## Product Change Notice (PCN)

**PCN Number:** PCN-0450260R-01

**Product(s) Affected:** MD-SM series (part numbers MD-30SM, MD-40SM, MD-50SM, MD-60SM, MD-70SM, MD-80SM, MD-90SM).

**Description of Change:** minor dimensional changes, and material changes, as shown below.

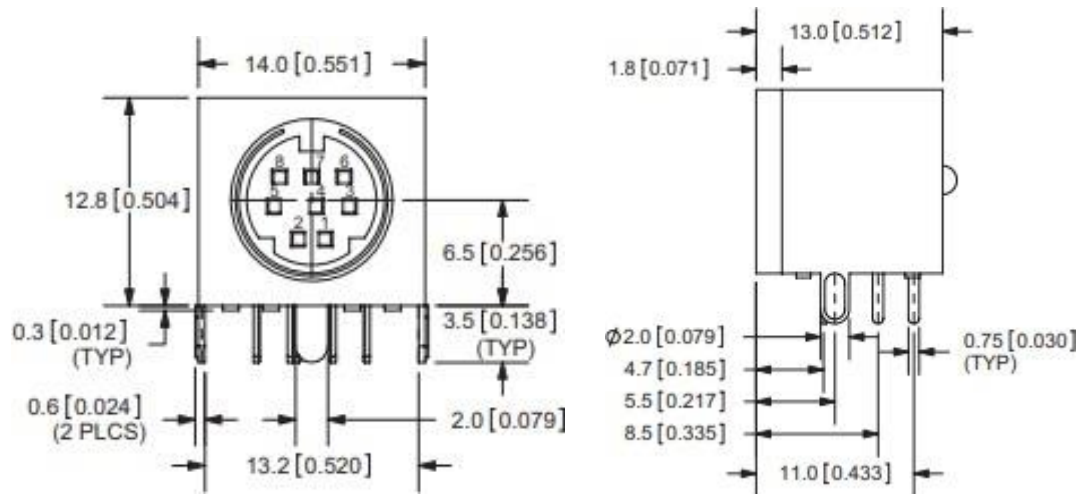
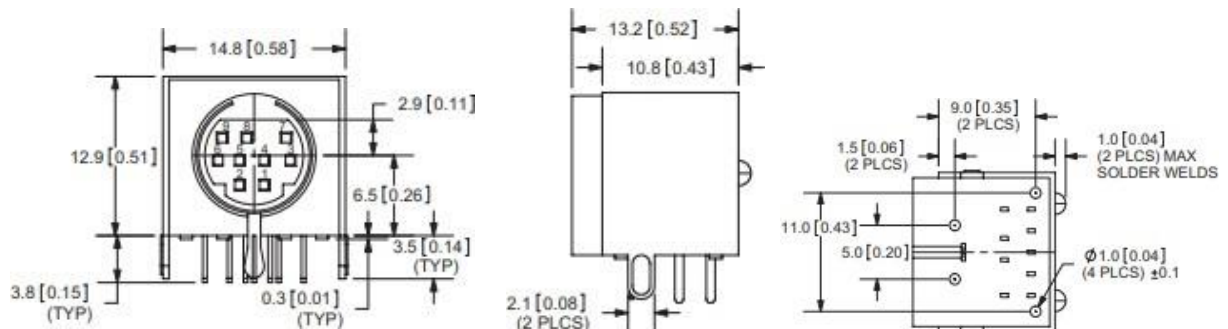
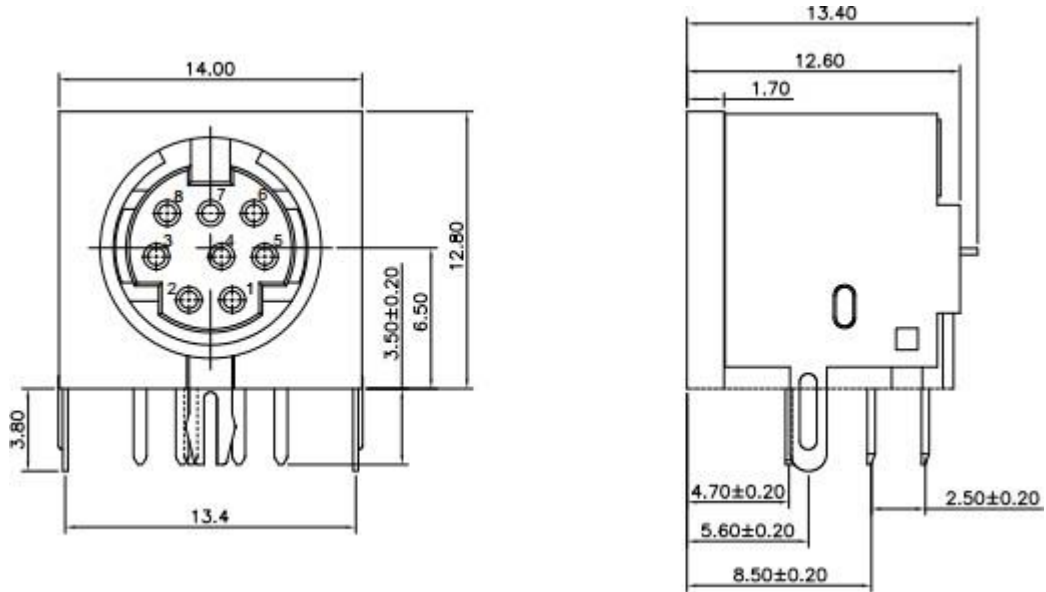
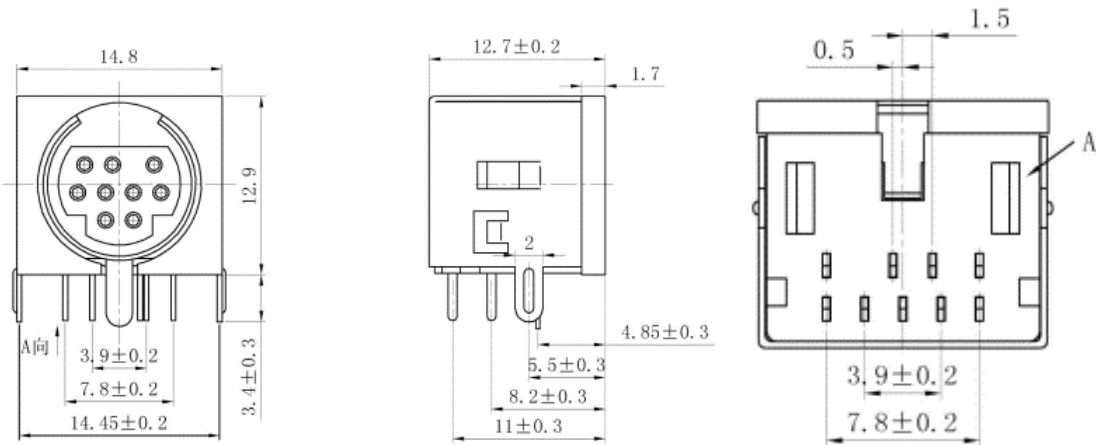
**Reason(s) for Change:** Manufacturing build location change.

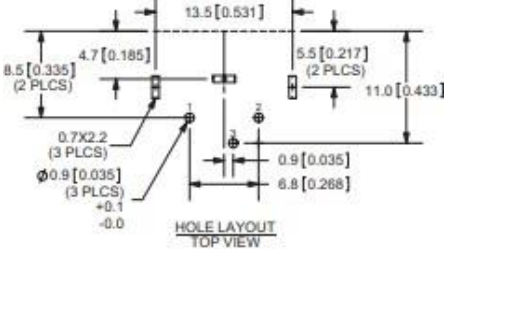
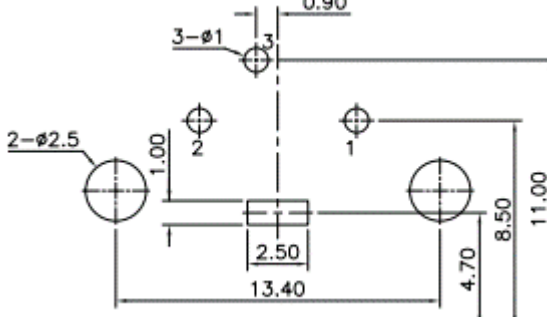
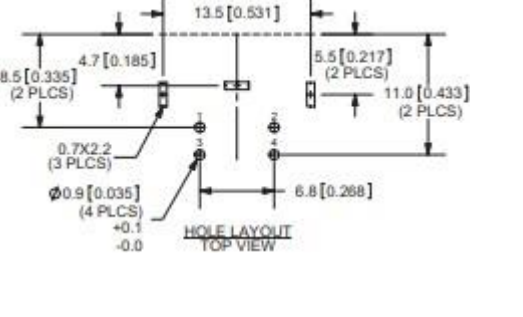
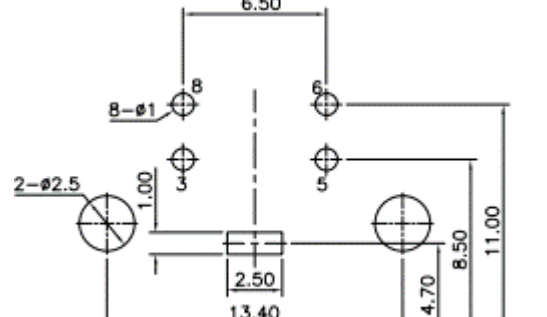
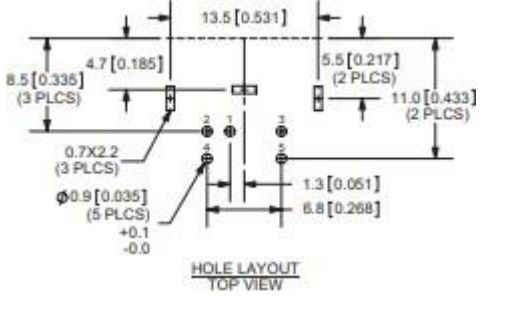
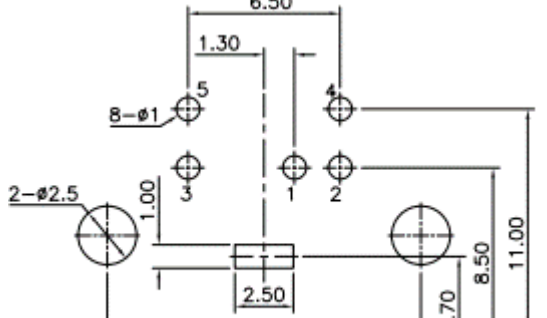
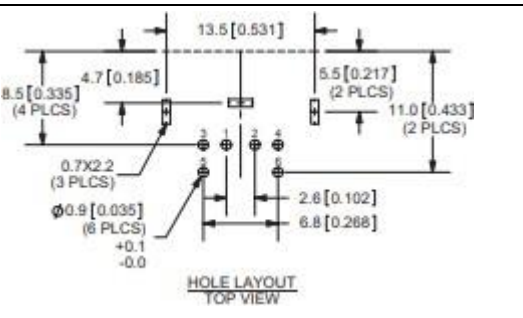
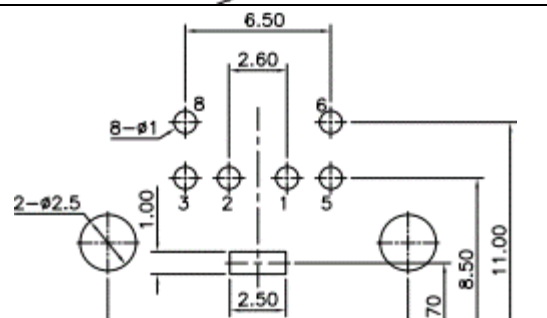
PCB Layout Old Design	PCB Layout New Design
 <p>HOLE LAYOUT TOP VIEW</p> <p>Dimensions: 13.5 [0.531], 8.5 [0.335] (2 PLCS), 4.7 [0.185], 5.5 [0.217] (2 PLCS), 11.0 [0.433], 0.7X2.2 (3 PLCS), <math>\phi 0.9</math> [0.035] (3 PLCS) <math>+0.1</math> <math>-0.0</math>, 0.9 [0.035], 6.8 [0.268]</p>	 <p>Dimensions: 0.90, 3-<math>\phi 1</math>, 2-<math>\phi 2.5</math>, 1.00, 2, 1, 2.50, 13.40, 4.70, 8.50, 11.00</p>
 <p>HOLE LAYOUT TOP VIEW</p> <p>Dimensions: 13.5 [0.531], 8.5 [0.335] (2 PLCS), 4.7 [0.185], 5.5 [0.217] (2 PLCS), 11.0 [0.433] (2 PLCS), 0.7X2.2 (3 PLCS), <math>\phi 0.9</math> [0.035] (4 PLCS) <math>+0.1</math> <math>-0.0</math>, 6.8 [0.268]</p>	 <p>Dimensions: 6.50, 8-<math>\phi 1</math>, 2-<math>\phi 2.5</math>, 1.00, 5, 5, 2.50, 13.40, 4.70, 8.50, 11.00</p>
 <p>HOLE LAYOUT TOP VIEW</p> <p>Dimensions: 13.5 [0.531], 8.5 [0.335] (3 PLCS), 4.7 [0.185], 5.5 [0.217] (2 PLCS), 11.0 [0.433] (2 PLCS), 0.7X2.2 (3 PLCS), <math>\phi 0.9</math> [0.035] (5 PLCS) <math>+0.1</math> <math>-0.0</math>, 1.3 [0.051], 6.8 [0.268]</p>	 <p>Dimensions: 6.50, 1.30, 8-<math>\phi 1</math>, 2-<math>\phi 2.5</math>, 1.00, 5, 4, 3, 1, 2, 2.50, 13.40, 4.70, 8.50, 11.00</p>

<p>HOLE LAYOUT TOP VIEW</p> <p>Dimensions: 13.5 [0.531], 8.5 [0.335] (4 PLCS), 4.7 [0.185], 5.5 [0.217] (2 PLCS), 11.0 [0.433] (2 PLCS), 0.7X2.2 (3 PLCS), <math>\phi 0.9</math> [0.035] (6 PLCS) <math>+0.1</math> <math>-0.0</math>, 2.6 [0.102], 6.8 [0.268]</p>	 <p>Dimensions: 6.50, 2.60, 8-<math>\phi 1</math>, 2-<math>\phi 2.5</math>, 1.00, 8, 6, 3, 2, 1, 5, 2.50, 13.40, 4.70, 8.50, 11.00</p>

## Old design materials

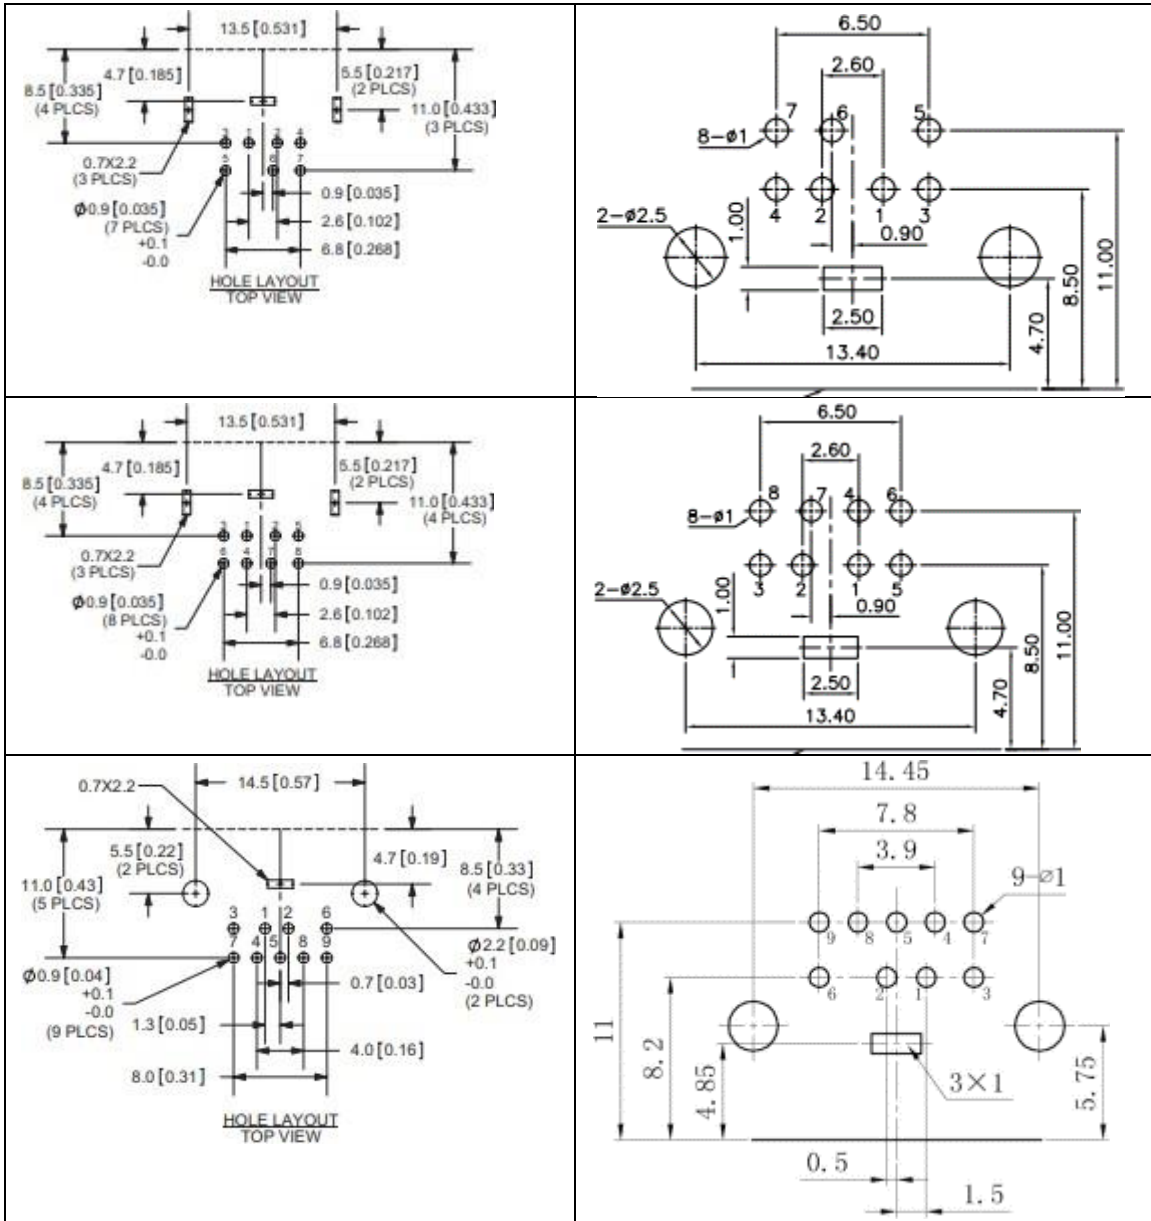
MATERIAL	PLATING
earth terminal	brass	tin
contact terminals (1~9)	phosphor bronze	silver
shielding plate	steel	tin
housing	PBT

MATERIAL	PLATING
body	PBT+30%GF (UL94V-0)	
pins	brass	tin
shield	brass	nickel
